Placer County Board of Supervisors 175 Fulweiler Avenue Auburn, CA 95603 May 18, 2015

Subject: Comments on S.R. 89/Fanny Bridge Community Revitalization Project Final EIR/S/EA (Project)

Figure 6.4

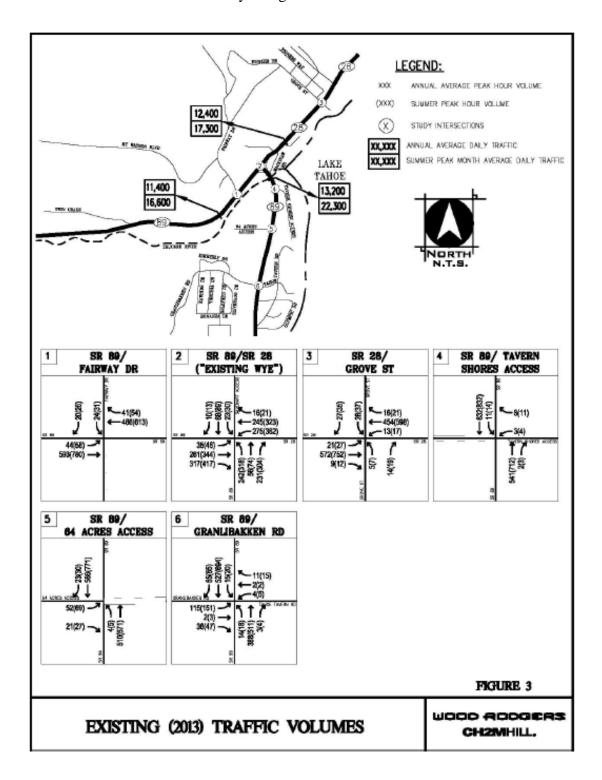
This graphic provides estimates for each county; note the Placer County increases are attributable to the Fanny Bridge Realignment Project. The estimated increased vehicle trips are noted as the 'daily vehicle trips.' Although the estimates to peak hour are not included, it is noteworthy that 730 trips/day is roughly double the general range in summer peak hour trips and more than double the general annual average peak hour trips, as noted in Figure 3 from Appendix G, the Travel Forecast and Operations Analysis Technical Memorandum:

Although the average trips per day and average peak trips per day are different units, the addition of 730 trips could be highly significant in light of the existing peak numbers.

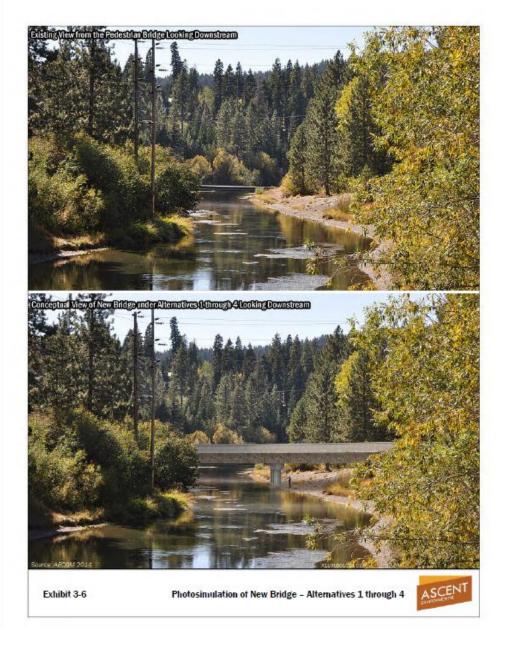
Although the EIR/EIS/EA's description suggests a fairly unobtrusive image of the new bypass bridge,³⁶ the bridge will not be constructed without disturbance to the land nearby, nor will it only have one small vehicle on it as depicted in Exhibit 3-6.

Simulations must include the bridge with vehicles, from other angles, including both sides of the river, from surrounding mountaintops and Lake Tahoe (from any point where this raised highway may be seen), and views without as many trees, since trees will be cut for the project (and more trees tend to die during or shortly after construction; South Shore's "Marriott/Heavenly Village" redevelopment is a prime example of this).

KOP 1:

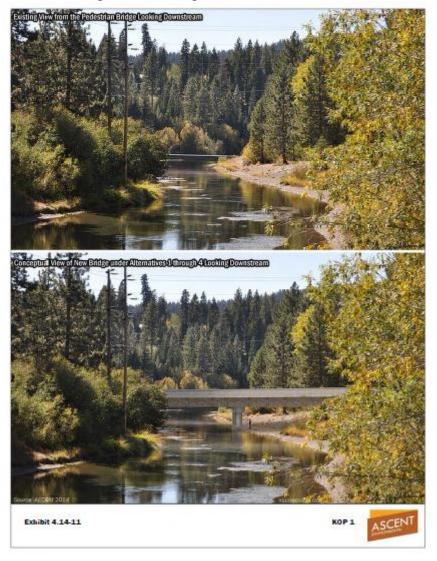
The EIR/EIS/EA presents the existing view from KOP 1, along with a simulated view of the bridge. However, the simulated view does not appear to represent a raised bridge, and it is unclear whether the bridge will be ten feet from the floor of the river, or ten feet above the bike path (which is presumed itself to be raised from the riverbed).

In addition, this image paints a far more pleasant picture than can be expected. For example, trees will be removed to construct this project. Vehicles will be crossing the roadway, creating dust and emissions. The EIR/EIS/EA must disclose the potential visual impacts of the project. Although the following images below have not been professionally created, they are included to represent the types of simulations that should be included in the DEIR/EIS/EA to better reflect the reality of what the impacts could be. The first image includes the EIR/EIS/EA's simulated bridge from KOP 1, however vehicles, emissions, and other highway debris have been added. The second image below includes a higher bridge, roughly raised another ten feet above grade level at the sides of the river, as it is unclear from the EIR/EIS/EA exactly how high the bridge will pass over the river.

KOP 2:

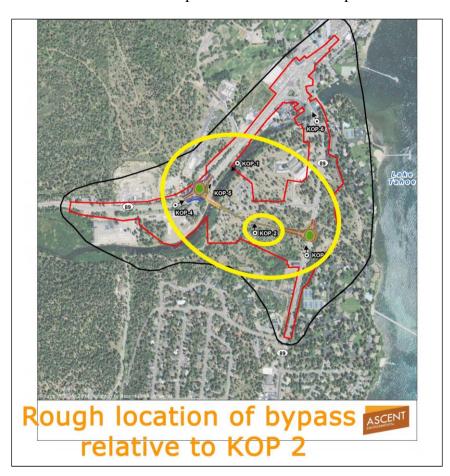
Oddly, the DEIR/EIS/EA includes no visual assessments of the impacts to KOP 2, which is an area representing the undeveloped forested section of the 64-acre Tract. The DEIR/EIS/EA acknowledges this point: "The view from KOP 2 consists of a forest scene that provides relatively intact forest vegetation, which does not contain any urban features." Although Exhibit 4.14-10 identifies the location of the KOPs, and the DEIR/EIS/EA notes the bypass will be visible from KOP 2 and other points in the 64-acre tract, the DEIR/EIS/EA fails to include a picture representing the existing view from KOP 2, let alone a simulation of what it would look like with the bypass in Alternatives 1-4.

In a rough comparison of the location of the new bypass to the KOP 2, it appears the bypass would be built in the same location as the KOP 2. The EIR/EIS/EA needs to clearly show the before and after impacts to this observation point.

KOP 5:

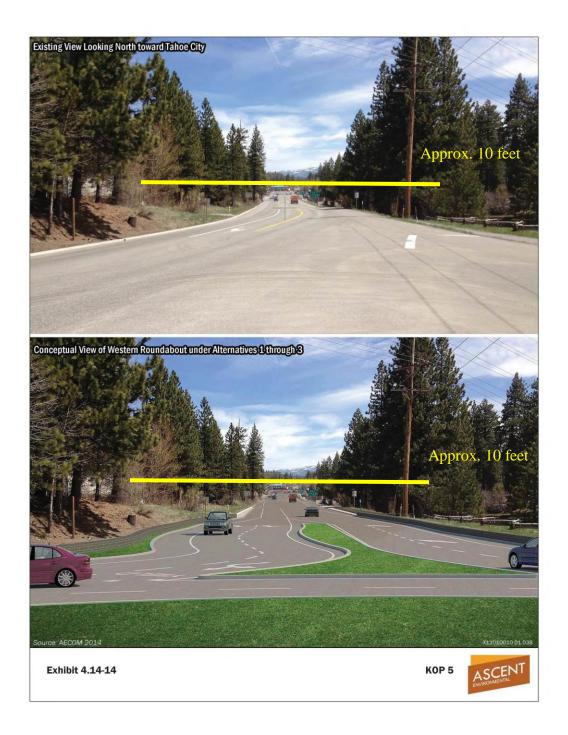
A local Tahoe City resident placed ten foot poles at the intersection labeled KOP 5 in the EIR/EIS/EA to represent where an elevated embankment would be. As the resident's picture reflects below, the elevated bypass would significantly change the views in this area.

However, the KOP 5 simulation in the EIR/EIS/EA appears to be based on ground level. If this bypass will be elevated above the existing ground level, the visual simulations need to clearly reflect the changes.
